PLAN COMMISSION MEETING AGENDA

**TUESDAY, September 27, 2016
AT 6:00 PM**

Plan Commission Report

PROJECT: Plan Review – Sam Dickman, Jr., The Dickman Company

Window graphics with window measurements

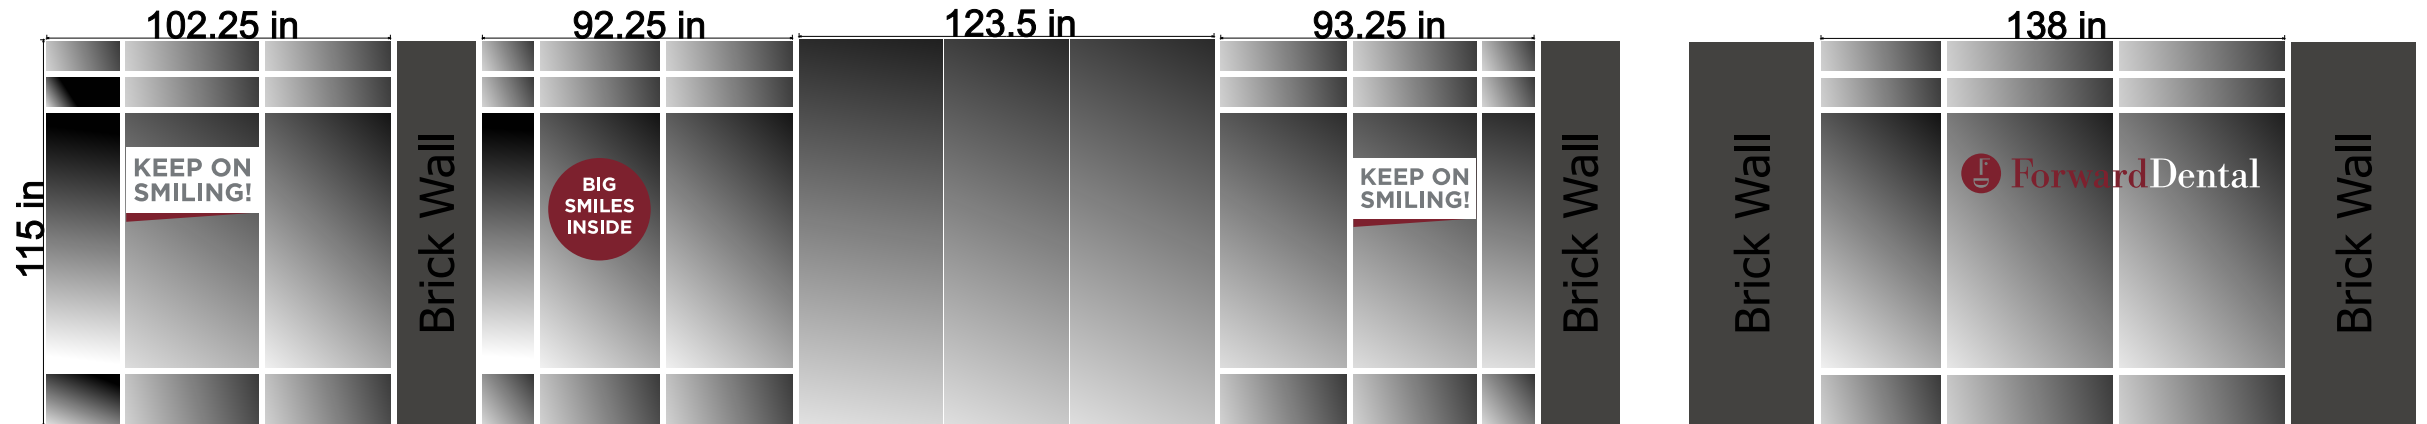
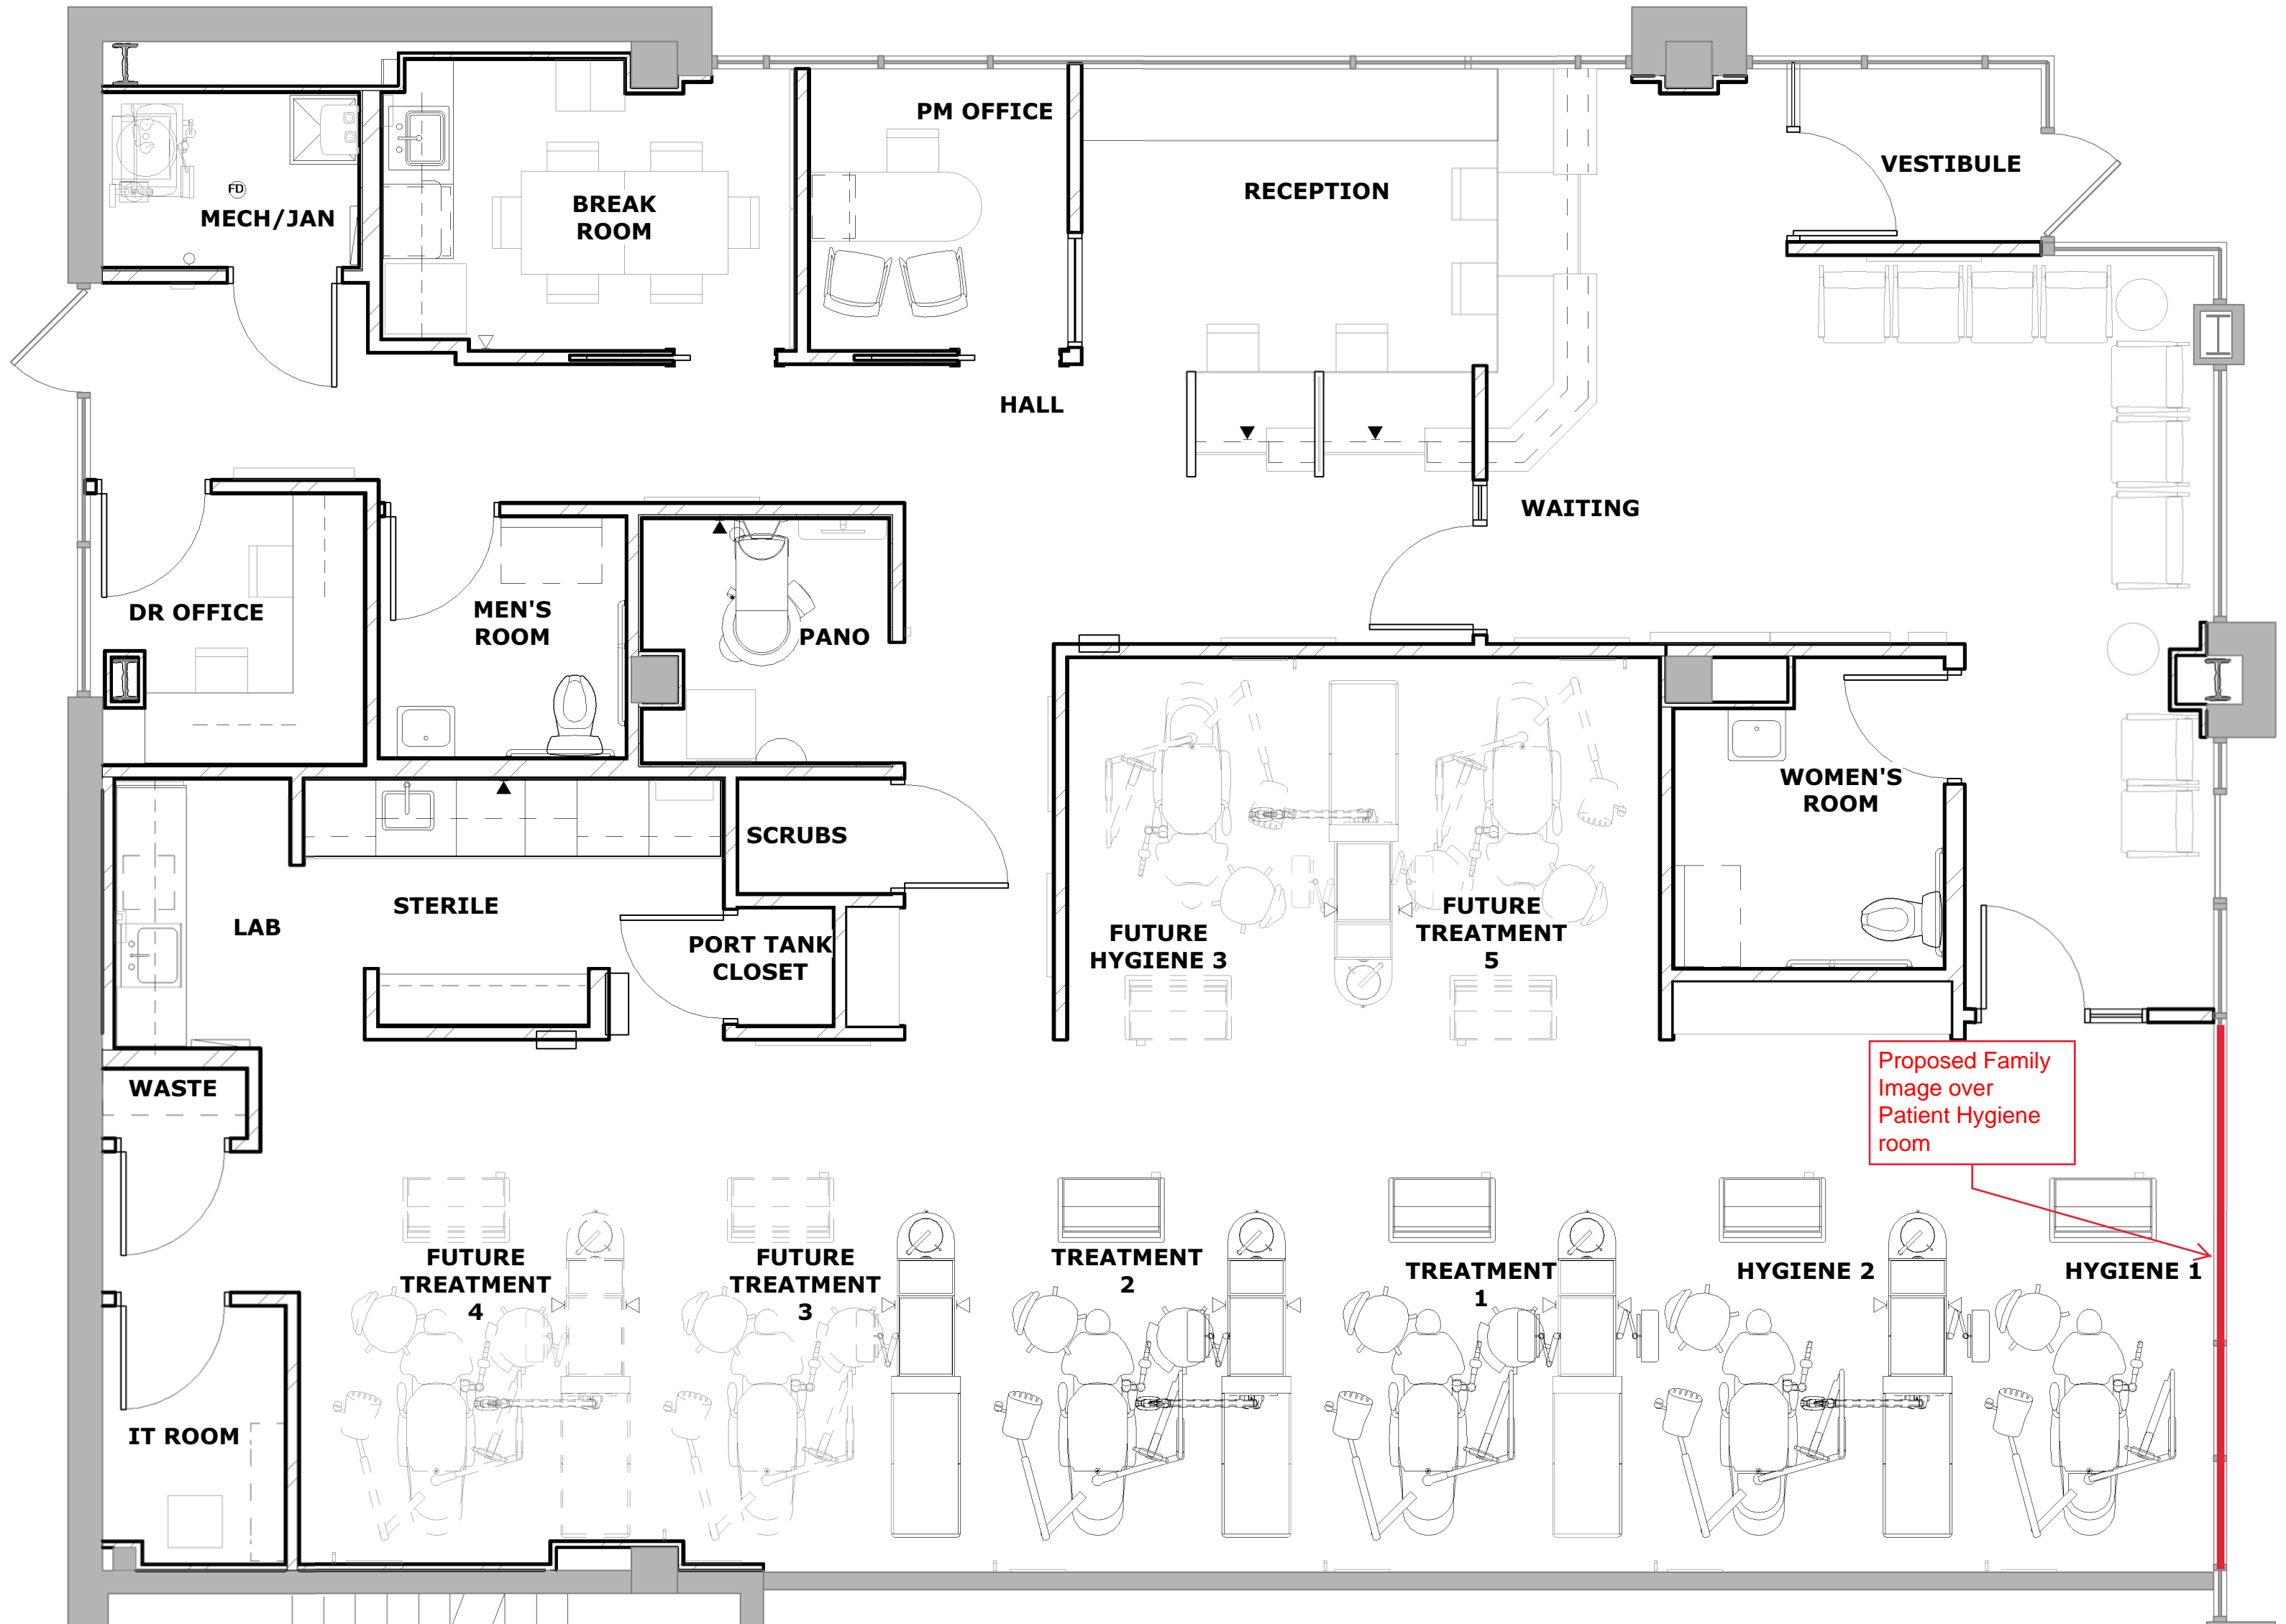
A total of ten eye level signs are being proposed on the east, west, and north elevations of the buildings. According to the DTSMUPDD Development Plan, eye level signs are only allowed on entry facades, no more than one sign per 12 linear feet, and not to cover more than 10% of the glazing. Based on the linear frontage of the entrance facade, a maximum of four signs would be allowed. The applicant is proposing six. Of these six signs, only two comply with the regulation that no more than 10% of the glazing to become opaque. The “family photo” eye level sign covers 42% (30.7 square feet) of the glazing. It will be 23 inches taller than the proposed wall sign. The applicant has stated that this area of the building is used for a dental hygiene space and would like to protect the privacy of their patients by installing this size eye level

sign. On the “corner” of the east elevation, the applicant would like to install three eye level signs. The sum of these signs covers 14.3% of the glazing of the “corner” east elevation. Furthermore, the “New Smiles Welcome” sign is 15 inches taller than what would be allowed for a wall sign. The remaining four eye level signs on the north elevation and one on the west elevation do not exceed the 10% rule, however, they are located on a non-entry façades which does not comply with the DTSMUPDD Development Plan which prohibits eye level signs on non-entry facades. The “Big Smiles Inside” sign will be 5 inches taller than the proposed wall signs on the building. Overall, four variances are required. Once variance allowing two eye level signs to exceed the 10% glazing rule. Another to exceed the number of eye level signs from four to ten and another variance to allow eye level signs on non-entry facades.

If the Plan Commission is comfortable with the proposed signs, the Plan Commission can approve the following variances for the tenant space located at 7955 S. Main Street:

1 WEST ELEVATION
1" = 20'-0"

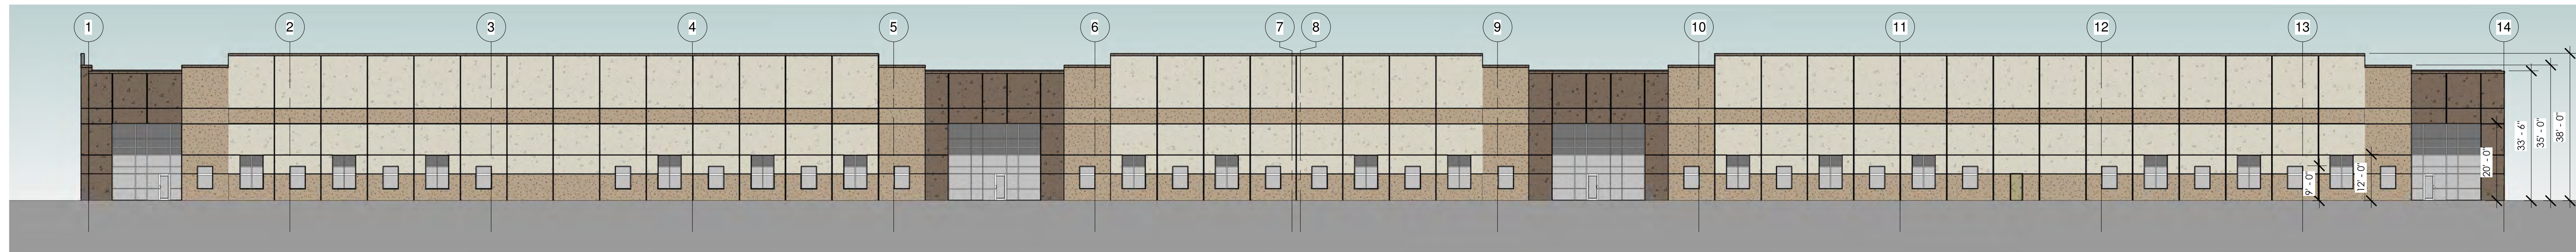
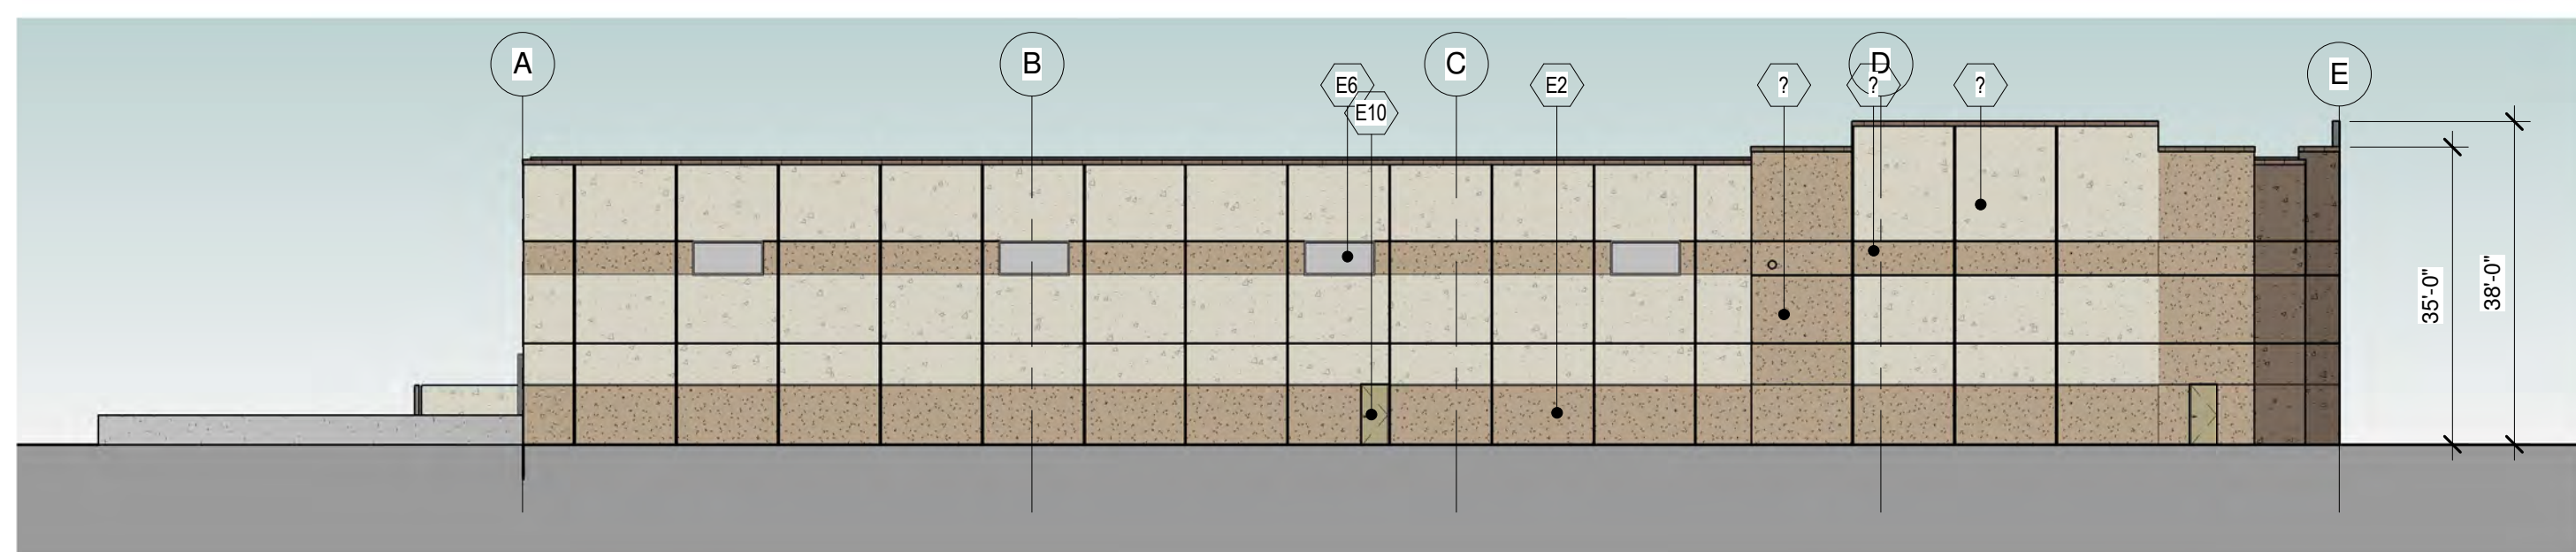
1. That all building and fire codes are met.
2. That the elevations are revised to incorporate glazing from the entrance elevation on the west around the northwest corner.
